# SERVICE BULLETIN

Service Bulletin No.: DAC1-25-01 Rev 3

Title: ME406 ELT installation

Figure 1:

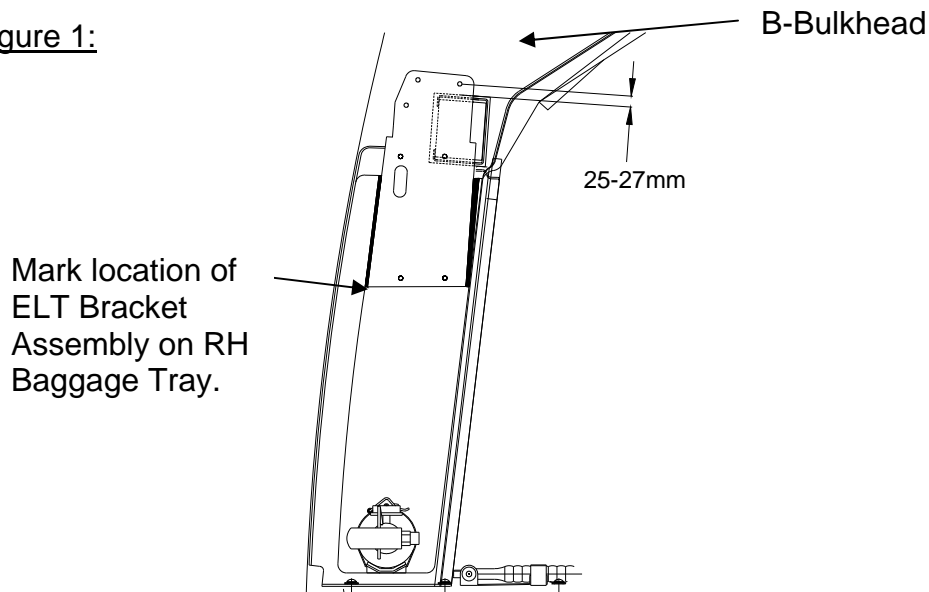
- 10.1 Remove baggage center floor as per AMM Chapter 25-10.
- 10.2 Remove existing EBC502 ELT and ELT tray. **Before removing ensure ELT switch is in the OFF position.**
- 10.3 Place ELT bracket assembly (22-2562-10-00) into RH baggage tray and position so that bracket assembly mounting holes are 25-27mm aft of existing ELT pocket. Mark bracket location on baggage tray. See Figure 1.

Figure 2:

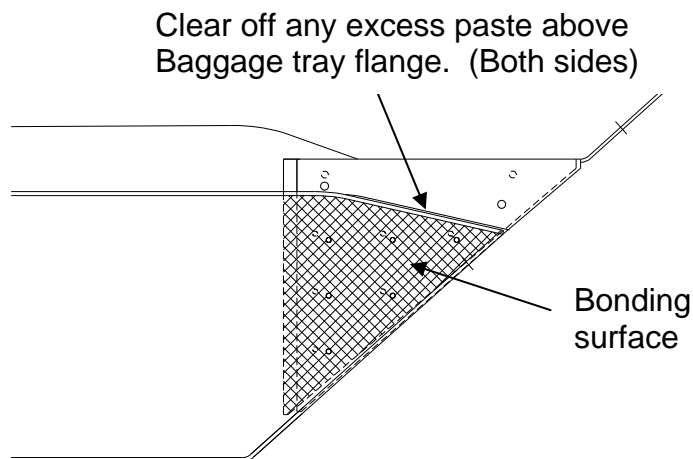
**10.10** Apply mixed resin to all bonding surfaces. See Figure 2.

Template:

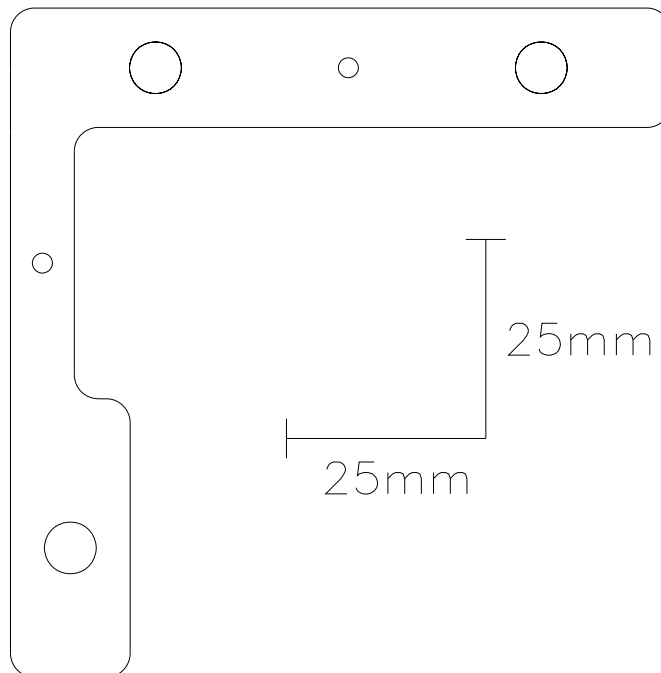
- 10.14** Install baggage/bracket tray into aircraft and mark and drill mounting holes into B-Bulkhead.
- 10.15** Remove baggage/bracket tray from aircraft and using the below template drill out rivet holes on B-Bulkhead. *Verify template printout is to scale.*

Figure 3:

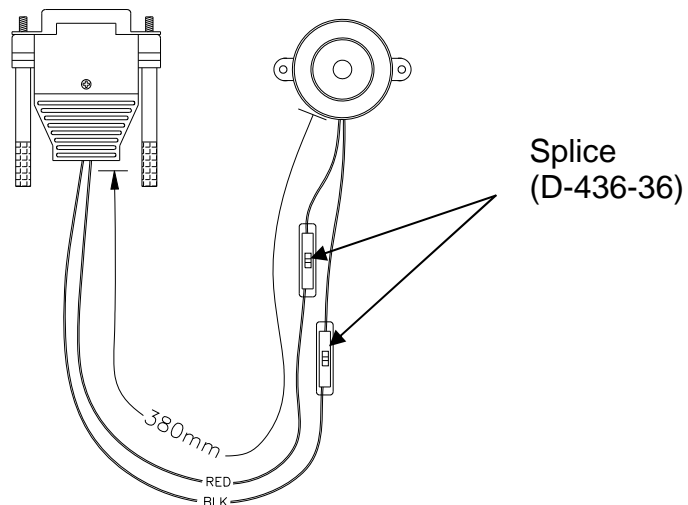
- 10.16** Install plate assembly (22-2562-30-00) in behind B-Bulkhead and rivet into place using two CCR244SS3-03 rivets.
- 10.17** Splice Artex ELT Interface module to Artex ELT buzzer using splices provided. See Figure 3.

Figure 4:

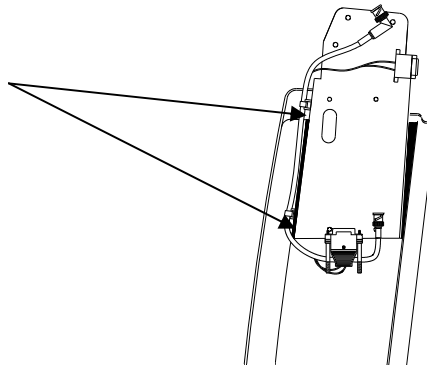
- 10.18** Route and secure ELT coax assembly and Interface module/buzzer onto baggage/bracket tray's cable tie bases. See Figure 4.

ELT Coax  
and Interface  
Module/Buzzer  
secured to  
Bracket  
Assemblies  
Cable Tie  
bases.

Figure 5:

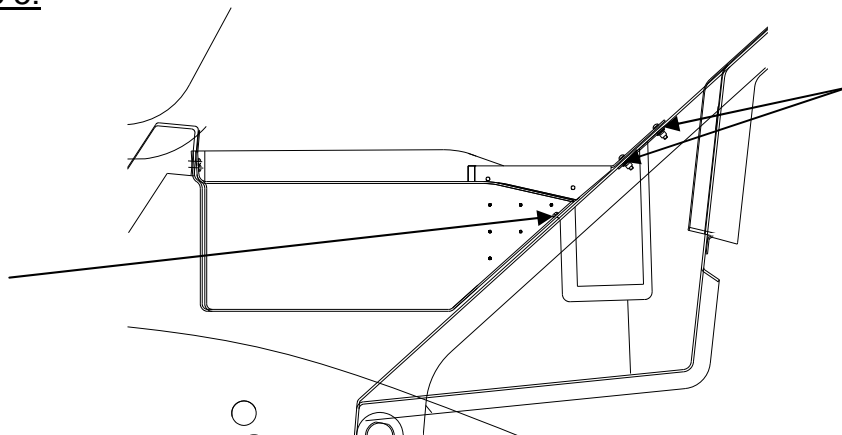
- 10.19** Re-install baggage/bracket tray. (Coax and Interface Module/Buzzer not shown for clarity). See Figure 5.

Replace existing  
mounting screw  
with the screw  
provided. (1x  
AN525-10R12)

Use mounting  
hardware  
provided.  
(3x AN525-10R12  
screw and 3x  
AN960-10  
washer)

Figure 6:

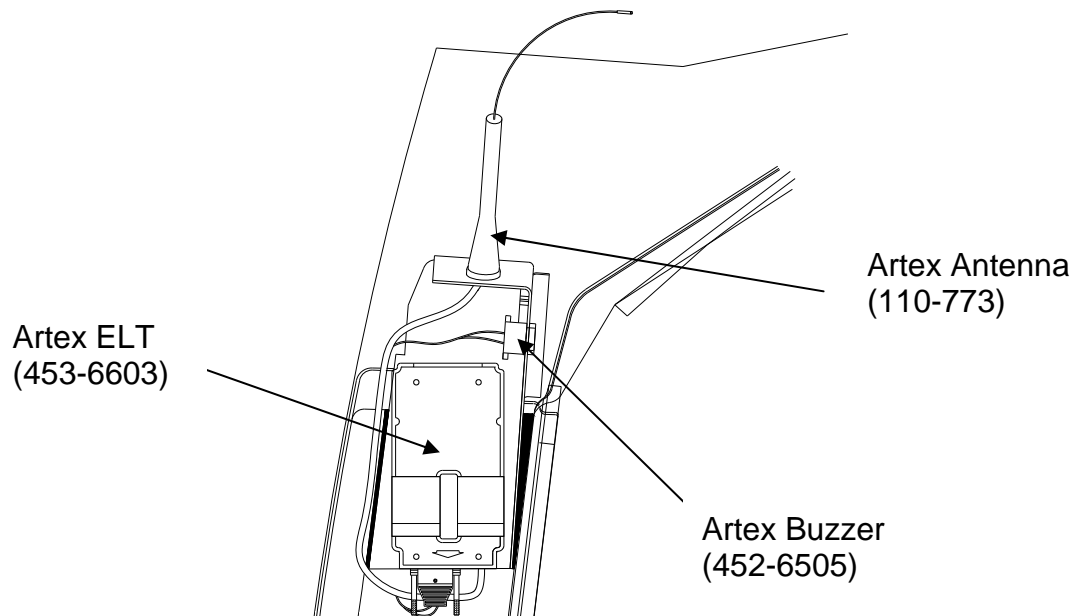
- 10.21 Install ELT side bracket (22-2562-20-00) onto ELT bracket assembly using 2x MS35206-230 screws and 2x AN960D6L washers. See Figure 7.
- 10.22 Install Buzzer into Side Bracket hole using the provided plastic bezel nut in accordance with the Artex ME406 Manual. See Figure 6.
- 10.23 Install Antenna into Side Bracket hole in accordance with the Artex ME406 Manual. Attach ELT Coax to ELT Antenna. See Figure 6.

Figure 7:

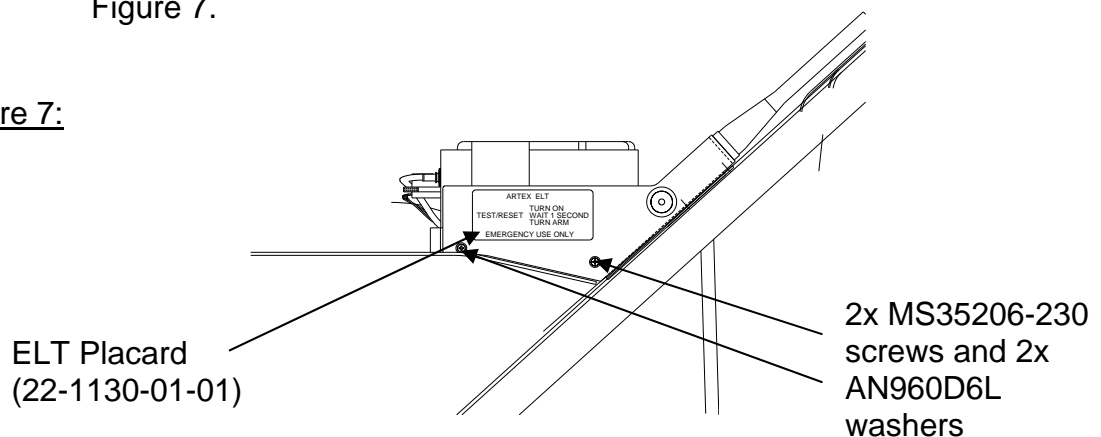
- 10.24 Install ELT Placard (22-1130-01-01) onto ELT Side Bracket. See Figure 7.
